## **Roberts Bank Terminal 2 Project**

### **Environment and Climate Change Canada (ECCC) Response to the Proponent's Public Comment Period Submissions**

**Figure 3: Trends in Western Sandpiper counts conducted at Roberts Bank between 1991 and 2019**

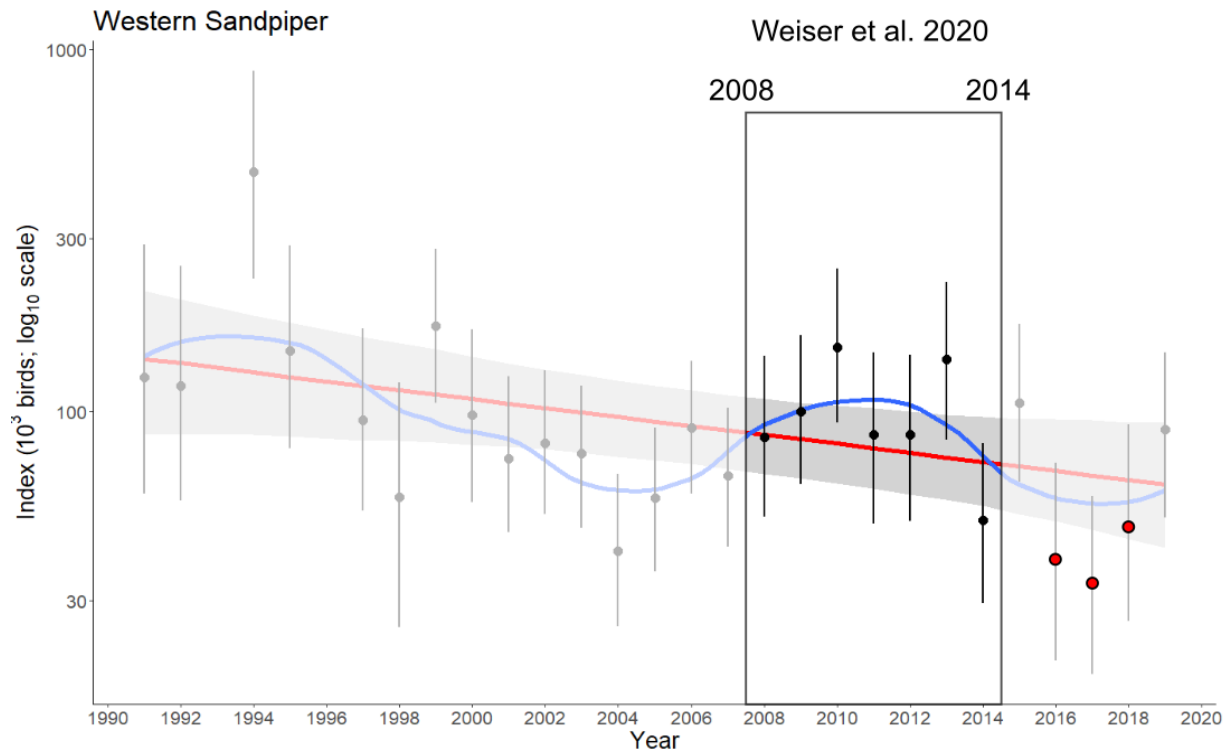
Assessments of the population status of migratory shorebirds can be made either through count-based population surveys, which measure abundance at a particular time or place, or with demographic models, which use estimates of vital rates to predict the population growth rate. Using a demographic model, Weiser *et al.* (2020) assessed an increase in Western Sandpipers over a 7-year period. The conclusions of that study contrast with the decreasing population trend estimated using 29 years (1991 to 2019) of spring shorebird surveys at Roberts Bank by Canham *et al.* (2021). Canham *et al.* (2021) estimated a 53% decline in Western Sandpiper abundance, after controlling for environmental variables (Fraser River discharge, tidal amplitude, and wind). Canham *et al.* also observed a positive average population growth rate in counts at Roberts Bank for the period assessed by Weiser *et al.* (2020) (average 1.08), suggesting the possibility of a short-term increase in the context of an overall long-term decline (average 0.97).

Short-term population fluctuations are often seen in long-term datasets (Figure 3). They can be driven by inter-annual variability in environmental conditions and predator-prey dynamics, and underscore the importance of long-term studies such as Canham *et al.* (2021).

Canham *et al.* (2021) also observed that the abundance of Western Sandpipers is negatively correlated with freshwater discharge from the Fraser River, the main driver of salinity at Roberts Bank. ECCC remains of the opinion that this correlation establishes a clear link between Western Sandpipers and salinity conditions at Roberts Bank, and indicates that changes to the hydrological regime arising from the Project would result in a lower abundance of sandpipers and exacerbate their ongoing long-term population decline.
